December 15, 2017

ND-17-1811
10 CFR 50.90
10 CFR 52.63

Southern Nuclear Operating Company
Vogtle Electric Generating Plant Units 3 and 4
Request for License Amendment and Exemption:
Consistency and Clarification Changes to Annex Building, Auxiliary Building
and Basemat ITAAC (LAR-17-040)

Figure 3 - Example 8-inch Floor on Metal Decking

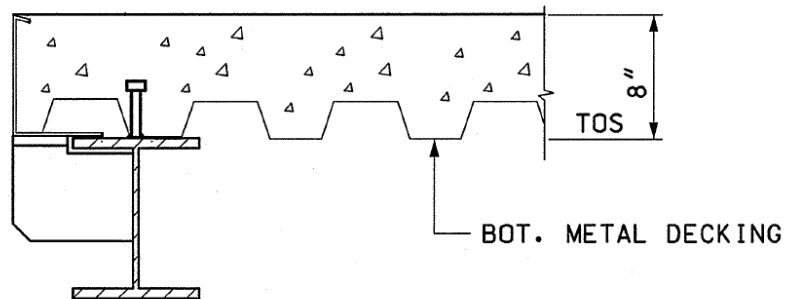
There are six floor sections in the Annex Building with ITAAC in COL Appendix C Table 3.3-1. The Annex Building concrete thicknesses in COL Appendix C Table 3.3-1 are consistent with the floor thicknesses as shown in UFSAR Figure 3.7.2-19 and include the depth of the metal decking as illustrated in Figure 3. However, by convention, the thickness to be indicated in COL Appendix C Table 3.3-1 is the concrete thickness, which for other buildings does not include the depth of the metal decking.

A change is proposed for the Annex Building concrete thicknesses in COL Appendix C Table 3.3-1 to add a note stating the concrete thickness for each floor reflects the thickness of the floor including the depth of the metal decking, where applicable. Table 1 presents a description of each Annex Building floor with ITAAC in COL Appendix C Table 3.3-1. Where the floor is supported on metal decking, the requisite sections making up the concrete thickness are presented.

- d. COL Appendix C Table 3.3-1:
 - i. Add new Note 12 to the Concrete Thickness acceptance criterion for each of the floors specified in Table 1 in this Enclosure stating the concrete thickness is the total floor thickness, including the metal decking, where applicable.
 - ii. For the Floor from column lines 9 to 13 and E to I.1 at elevation 117'-6", apply new Note 13. Add Note 13, stating the concrete in the kitchen and restroom areas is 2 inches thinner.
